Agua file: 023-01.340

October 25, 2016

**RE: Banks Crescent – Proposed 302 Unit Multi-Family Development
Preliminary Engineering Review – Water Supply Requirements**

Figure 1.2 - Existing Local Water Mains

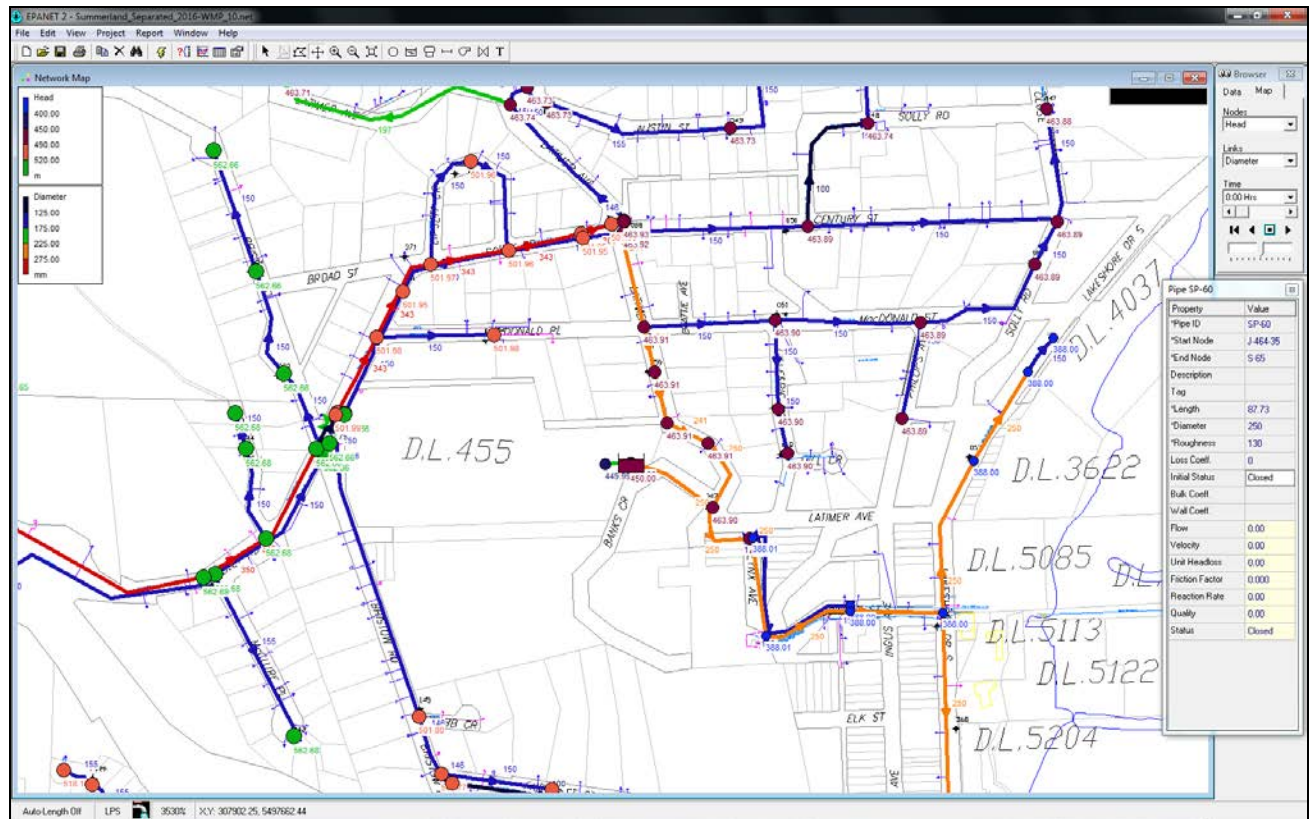
Figure 1.2 presents the existing hydraulic grade lines (HGL) for off-site water mains near the development site. There are three pressure zones in the vicinity of the site, PZ 563 (green nodes), PZ 501 (orange nodes) and PZ 463 (brown nodes). All zone identifications are based on the hydraulic grade line of the water system under maximum day water demand. The pressure zones all feed down from the Summerland Water Treatment Plant which has an operating HGL of approximately 586 metres.

PRV 8, which is a 200mm valve with 75mm low flow valve, exists on Solly Road that connects PZ 563 to PZ 501. PRV 7, which is a 200 valve with 75mm low flow valve, exists on Solly Road at Latimer Avenue and connects PZ 501 to PZ 463.

Figure 3.1 - Residual HGL and Unit Head loss

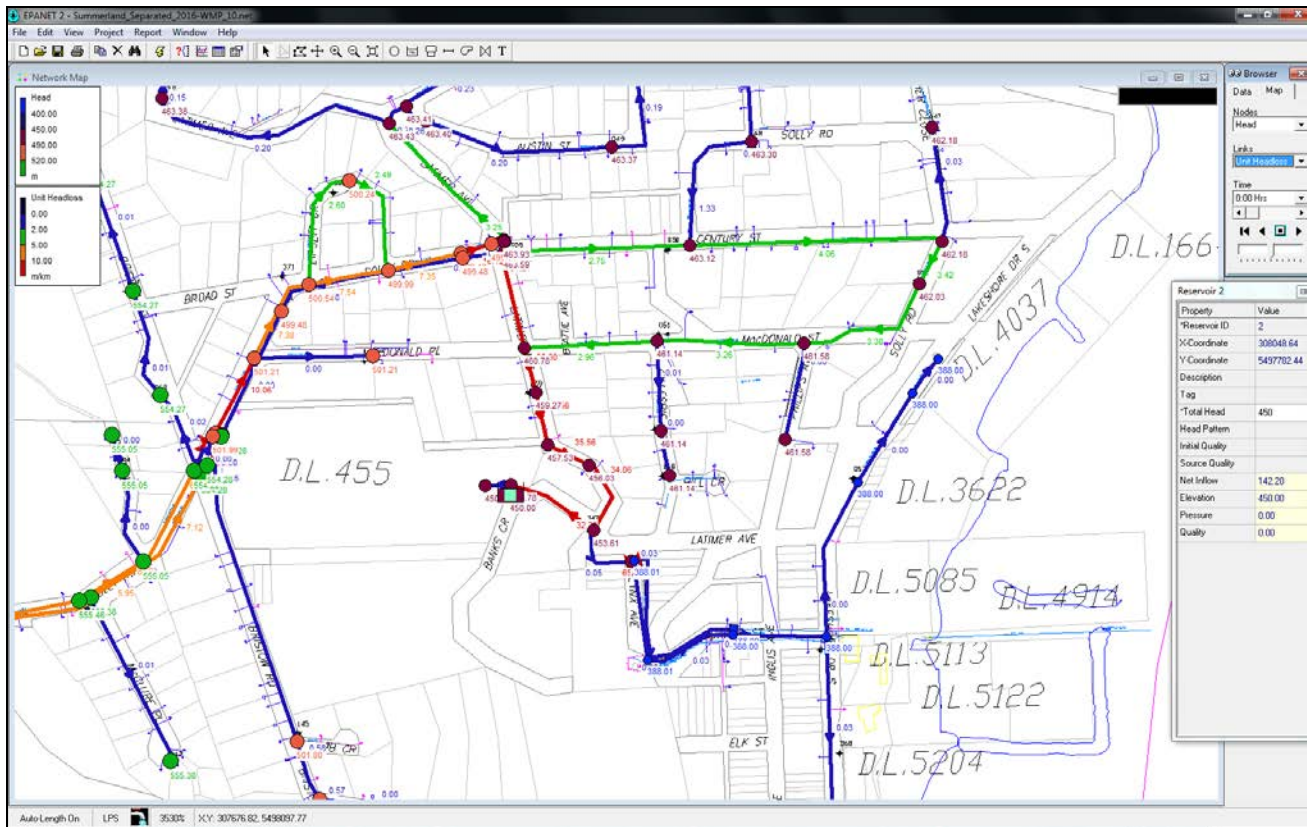
The computer model was tested to determine the available water from PZ 463. A criteria limiting water supply capacity is the 4.0 m/s maximum velocity under fire flow. For a 250mm diameter main this limits flow to 196 L/s. When subtracting the MDD for irrigation and domestic demands, this is further reduced by 6.0 L/s to 190 L/s available for fire flow.

As modelled, there is 140 L/s, subtract the 6.00 L/s for irrigation and domestic demands, there is only 134 L/s fire flow capacity to the site with a residual HGL of 450m. A residual hydraulic grade line of 450 metres is insufficient to get sufficient water pressure to the upper building floor fire sprinklers.

With the highest floor at elevation 425 metres, a residual HGL of 472 metres is desired to get sufficient pressures to the sprinkler system. There are options for the developer to consider for the sprinkler system including an in-building fire pump system with emergency generator or connect to a higher pressure zone.

Results of pressure drawdown versus flow from the Summerland mains in PZ 463 is presented in Figure 3.1 and summarized in Table 3.1.

* Exceeds maximum velocity criteria of 4.0m/s in 250 mm diameter water main

Figure 3.2 – Available HGL at Development Site

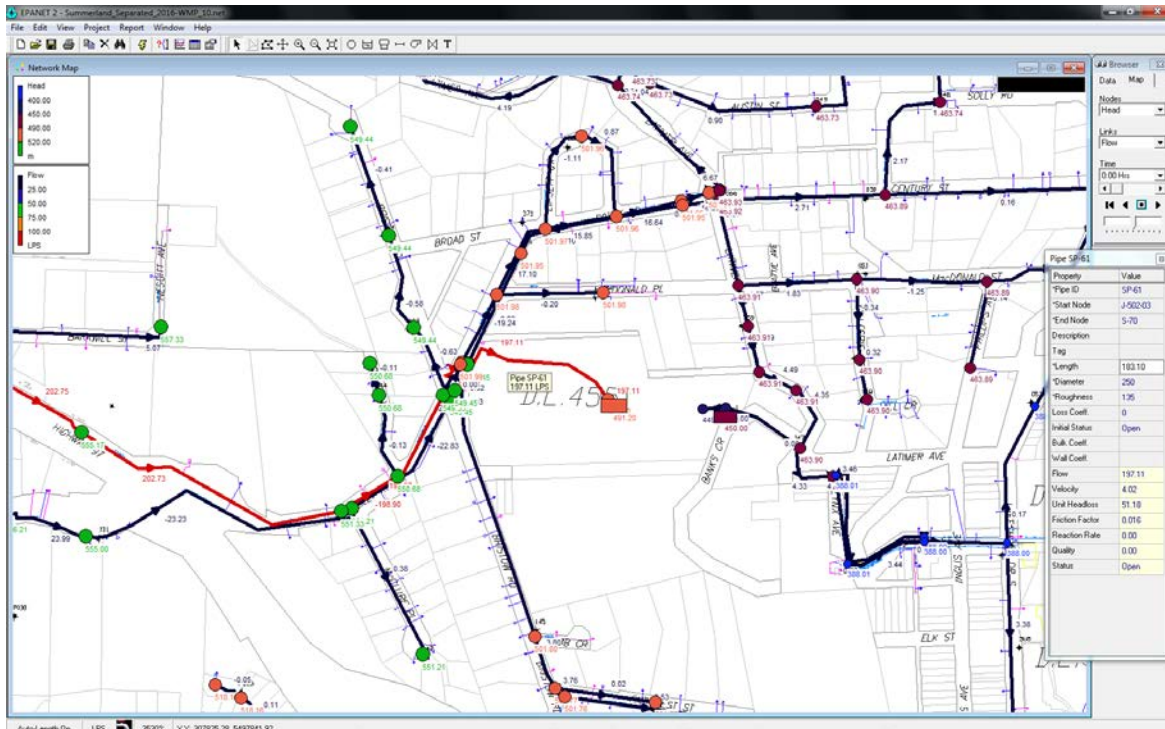
Supplying water to the site from Solly Road is viable as the main size and hydraulic grade line is sufficient to provide water to the highest floors of the proposed buildings, i.e. the fire protection sprinkler system. With a HGL at 502 meters elevation, a 180m length of 250mm diameter water main would be required to get the water from Solly Road, down the steep bank to the development site.

Based on a maximum pipe velocity of 4.0 m/s, if a 250mm diameter main is used, then a maximum flow of 196 L/s can be provided. If a 300 mm diameter main is used, then based on velocity, a theoretical maximum flow of 270 L/s can be provided to the site, however this is limited by fire storage to 225 L/s.

The service water main would have to be routed to a central location on-site, likely to a mechanical room in the parking garage where it could pass through a PRV station to drop the HGL so that pressures are not excessive at the lowest service elevations. It is likely that the pressure only has to be dropped by 20 m of head. From the central on-site location, the water could be routed through to the on-site hydrants.

Results of pressure drop versus flow for this option is presented in Figure 3.2 and summarized in Table 3.2.

** model run with 300mm diameter main due to max. velocity achieved at 197 L/s for 250 main*

If a 300 mm diameter main were utilized, the 4.0 m/s velocity criteria would not be exceeded until the flows were at 280 L/s.

To be consistent with the 2008 Water Master Plan, it was identified that the maximum fire flow available to the downtown core was 225 L/s for a duration of 2.875 hours. The fire flow to this site cannot exceed that rate and duration of flow. As a precaution, Summerland should check to see that there is 2911 m³ of water storage in the WTP clear well at all times of operation.
